Subject: Arkansas Nuclear One - Unit 2
Docket No. 50-368
License No. NPF-6
Response to Request for Additional Information on Meteorological
Data Regarding the ANO-2 Power Uprate License Application

**Response to NRC Staff Request for Additional Information on
Meteorological Data Regarding the ANO-2 Power Uprate License Application**

Figure 1

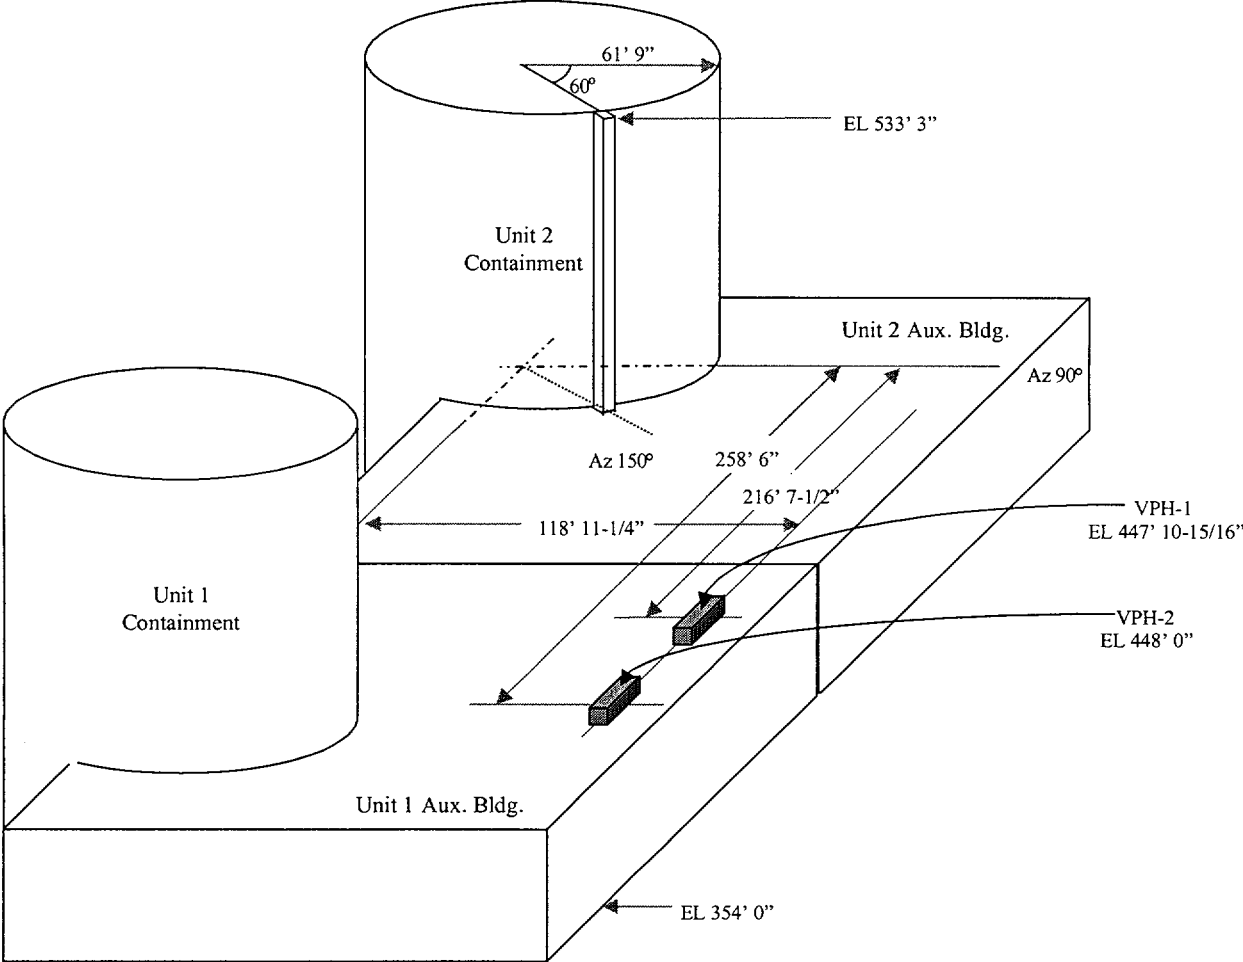
Provide references to figures showing structures, dimensions, and distances helpful in describing the postulated transport of the effluent. Are all directional inputs defined in terms of true north? If the figures are drawn to plant or magnetic north, what is the relationship to true north? If more than one release to the environment/transport scenario could occur (e.g., loss of offsite power and non-loss of offsite power, single failure), were comparative χ/Q calculations made to ensure consideration of the limiting dose?

Yes, comparative χ/Q calculations were made to ensure consideration of the limiting dose. Figures 1 and 2 are schematics of the layout from the release locations to the control room intake locations. These schematics have been taken from the plant figures, which are drawn in relation to true north. The magnetic declination at the ANO-2 site is very small, less than 3 degrees. Consideration of various intake locations has been described in the attachment to the August 4, 2000, letter. These various intake locations and release points have taken into account the considerations of single failures of the redundant control room ventilation fans and loss/non-loss of offsite power. Ventilation Penthouse 1 (VPH-1) and VPH-2 located on top of the auxiliary building roof were determined to be the two most significant intake locations. The potential release locations have been identified above, in the attachment to the August 4, 2000, letter and in Section 7.3.10.4 of Enclosure 5 to the December 19, 2000, license application. The relative location from the release points to both intake locations has been provided and considered in determining the limiting dispersion factors.
